SUBJECT: Forwards response to NRC 830627 request for addl info to satisfy requirements of NUREG-0737, Item II.D.1 "Relief & Safety Valve Testing."

Subject: Docket Nos. 50-361 and 50-362  
San Onofre Nuclear Generating Station  
Units 2 and 3

RESPONSES TO NRC QUESTIONS ON  
PRESSURIZER SAFETY VALVES  
SAN ONOFRE NUCLEAR GENERATING STATION  
UNITS 2 AND 3

COMPARISON OF THE SAN ONOFRE UNITS 2 AND 3 FSAR SAFETY VALVE  
FLOW MODEL AND DRESSER 31709NA VALVE  
OPERATING CHARACTERISTIC OBSERVED IN EPRI TESTS

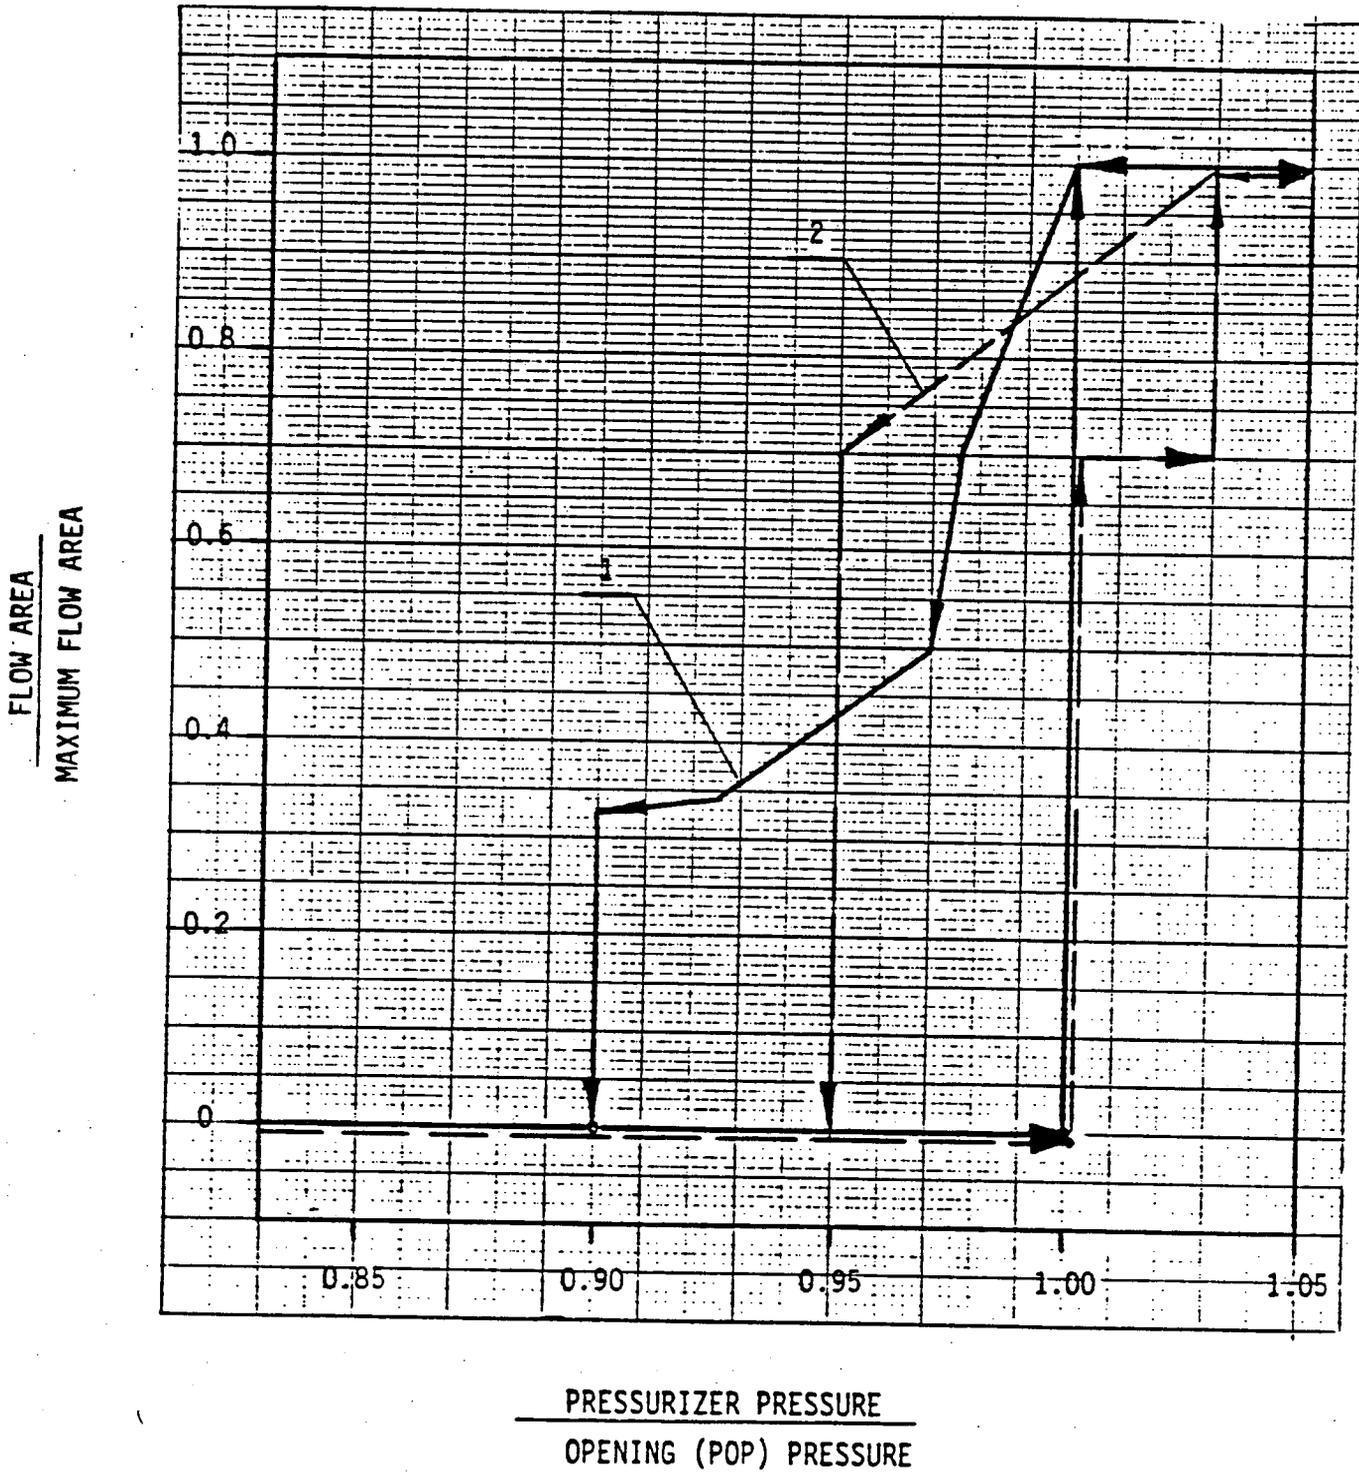
The ability of the valves to pass the flow to be compatible with the FSAR analyses that demonstrate the overpressure transients will be limited to 110% of the design pressure is inferred from data of Tables 3.3. and 3.5 of the submittal. However, no direct comparison was presented and considerable interpretation is required to reach this conclusion. A specific comparison of the measured flow characteristics with the characteristics used in the FSAR should be included in the submittal.

A direct comparison of the measured safety valve flow characteristics with the characteristics used in the FSAR is shown in Figure 1. The dashed line illustrates the FSAR assumption that the valve initially opens to only 70% of the maximum flow area at the set pressure until 3% overpressure is reached when the valve opens fully. The operating characteristic observed in the EPRI tests, depicted by the solid line, indicates that the valve pops open to the maximum flow area at the set pressure and remains there as the inlet pressure accumulates. Since the actual valve flow area will be greater than or equal to the valve flow area assumed in the FSAR analyses for pressures greater than the set pressure, it is concluded that valve will pass flow greater than or equal to the analysis flows. Therefore, the peak pressures calculated in the FSAR analyses are conservative.
